Well Name: MERAK 7 FEDERAL	Well Location: T17S / R30E / SEC 8 / SWSW /	County or Parish/State:
Well Number: 52H	Type of Well: OIL WELL	Allottee or Tribe Name:
Lease Number: NMNM007752	Unit or CA Name:	Unit or CA Number:
US Well Number: 3001548967	Well Status: Approved Application for Permit to Drill	Operator: SPUR ENERGY PARTNERS LLC

Sundry ID: 2666990

Type of Submission: Notice of Intent	Type of Action: APD Change
Date Sundry Submitted: 04/14/2022	Time Sundry Submitted: 07:51
Date proposed operation will begin: 08/01/2022

WELL LOCATION AND ACREAGE DEDICATION PLAT

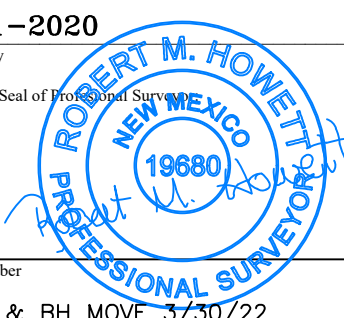
Procedure Description: Spur respectfully requests to shift this development to align with our spacing. No new surface disturbance. Permitted: SHL: 855' FSL 1060' FWL FTP: 400' FSL 100' FEL LTP: 400' FSL 100' FWL BHL: 400' FSL 50' FWL Proposed: SHL: 855' FSL 1060' FWL FTP: 850' FSL 100' FEL LTP: 850' FSL 100' FWL BHL: 850' FSL 50' FWL Please find updated C-102, directional information and drill plan attached for your use.

UL or lot no.	Section	Township	Range	Lot Idn	Feet from the	North/South line	Feet from the	East/West line	County
4	7	17S	30E		850	SOUTH	50	WEST	EDDY
